ADDENDUM

No. 05 Date: 9/26/2024
Project No. 0020711.01 Attention: Leonard D'Souza
Project Name: Princess Margaret Cancer Centre
Stem Cell Transplant 2, MHC, MHDU, DSC
Address: University Health Network
610 University Avenue
Toronto ON

Addendum #: M-4

Addendum #: E-4
Revision #: 0

E0109

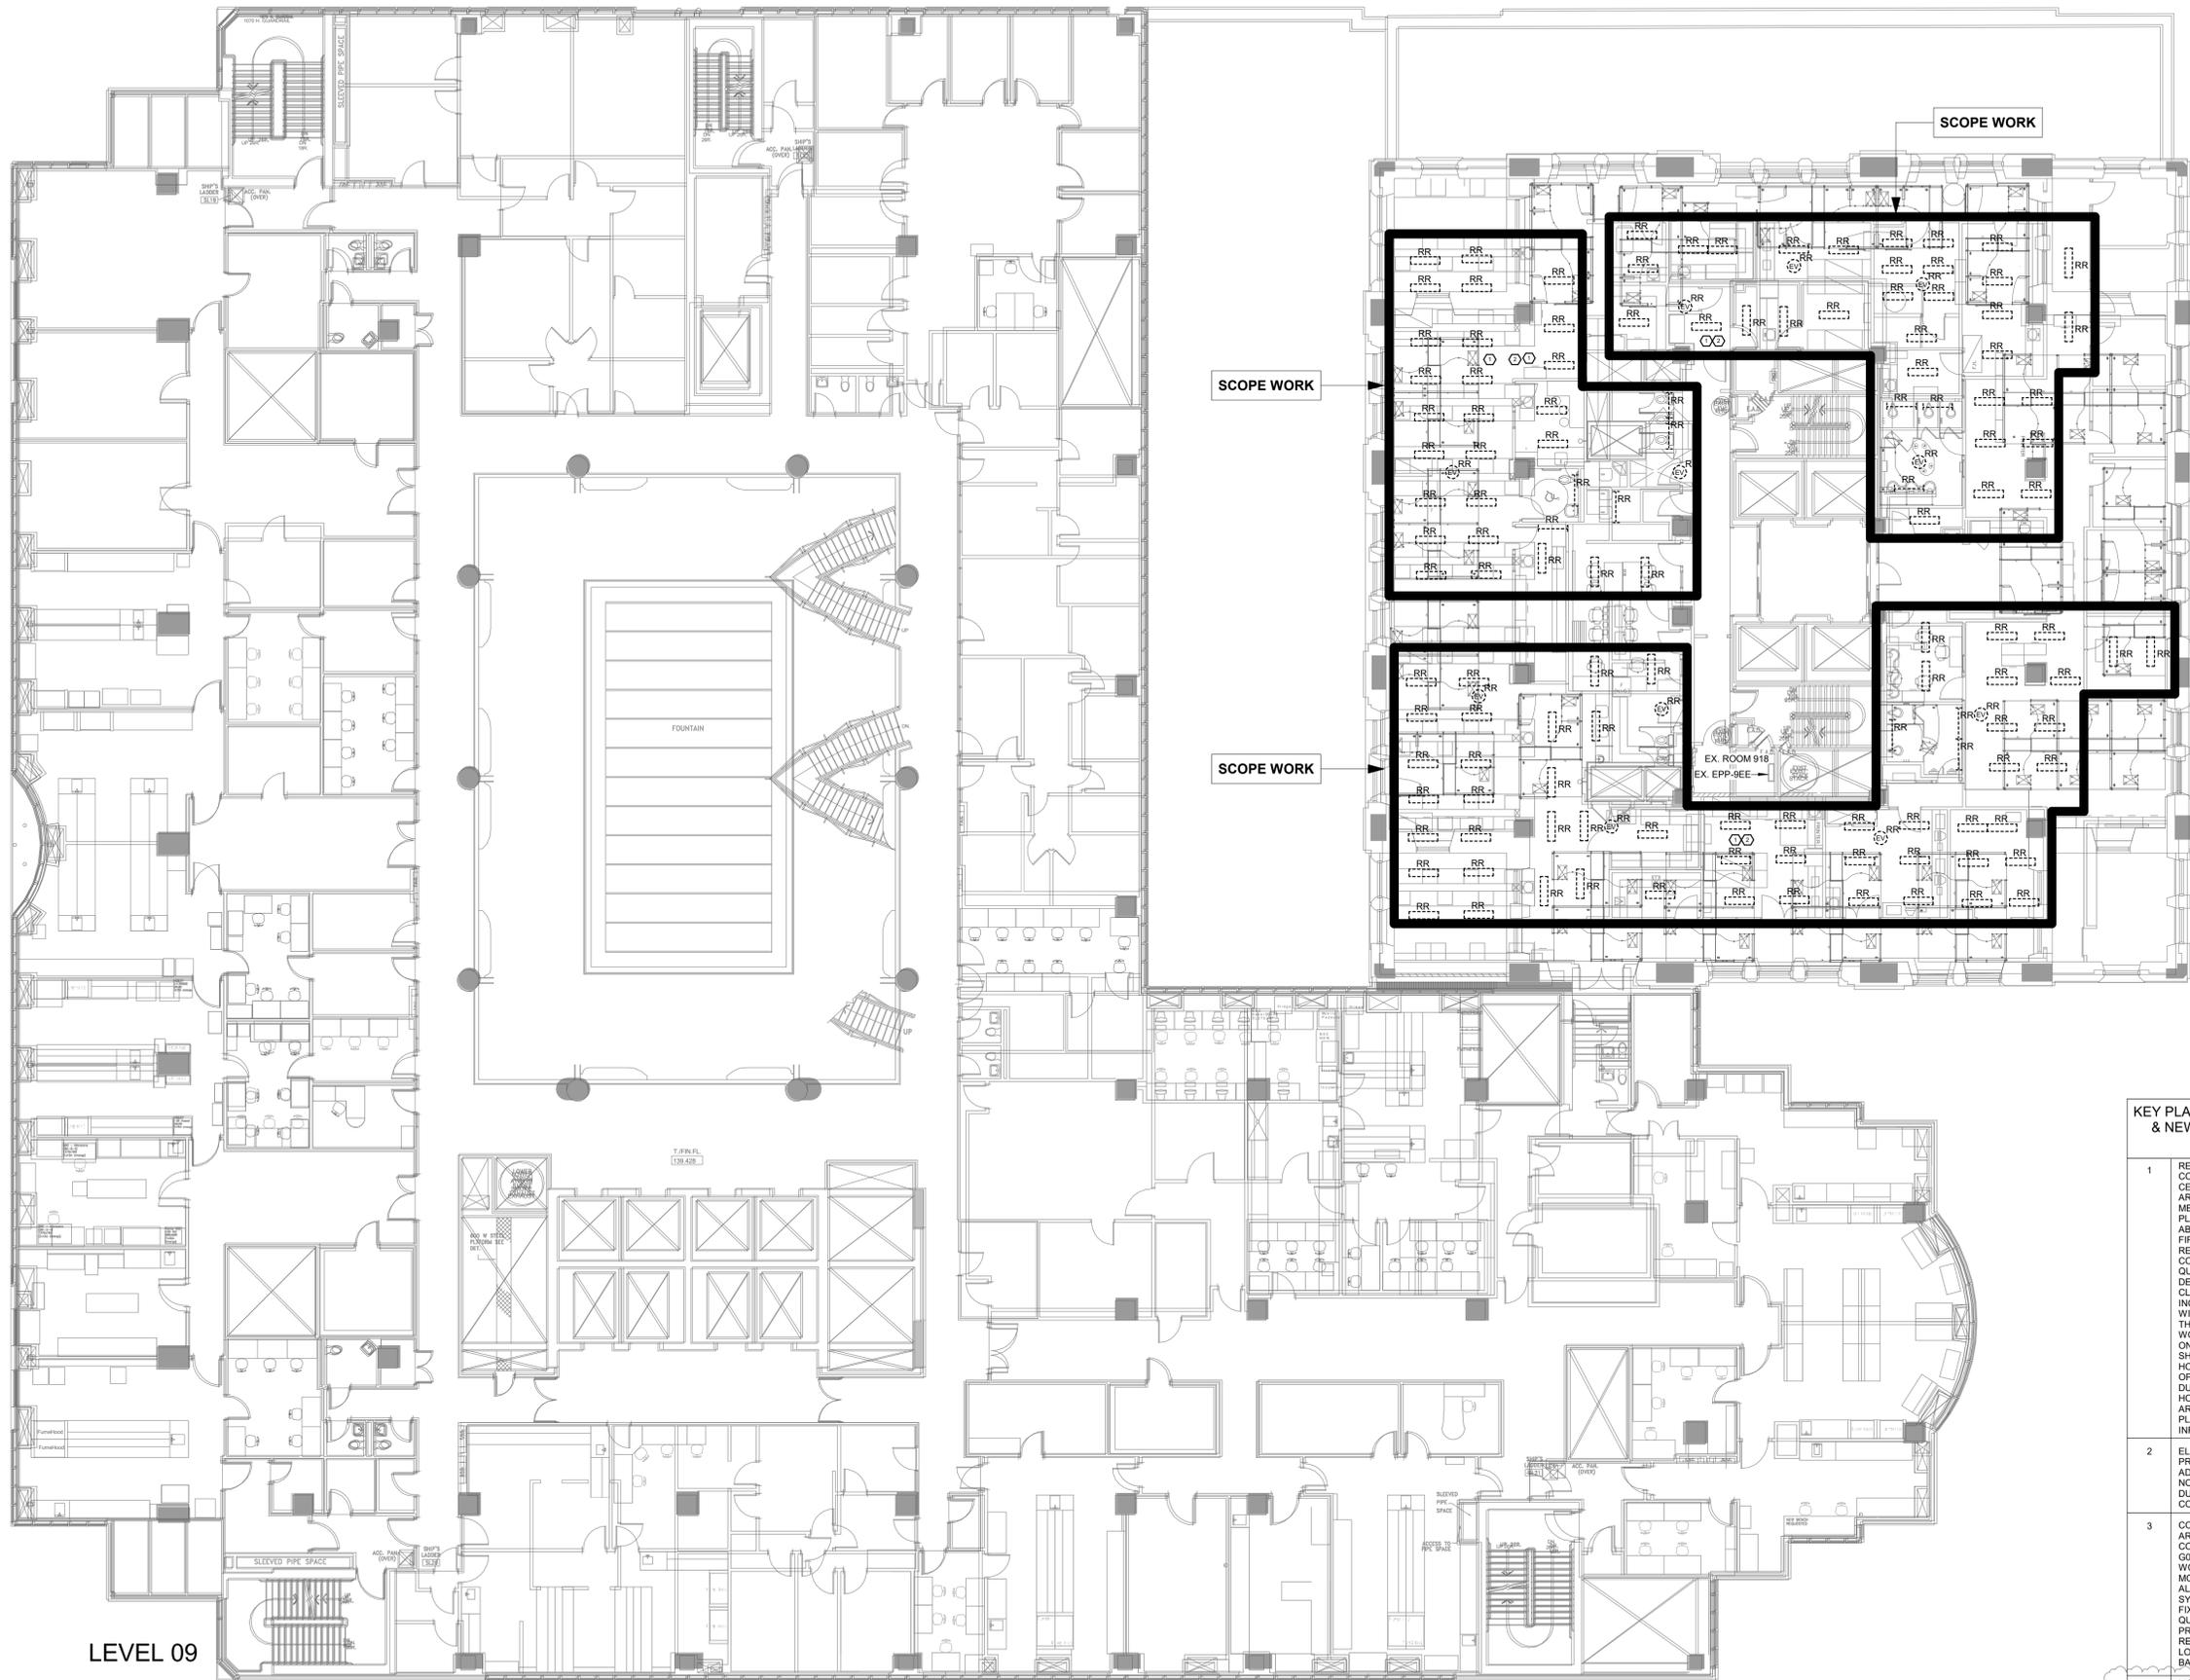
- Modification to notes as clouded, to provide provisions to disconnect, reconnect and test shaft lighting affected by demolition.
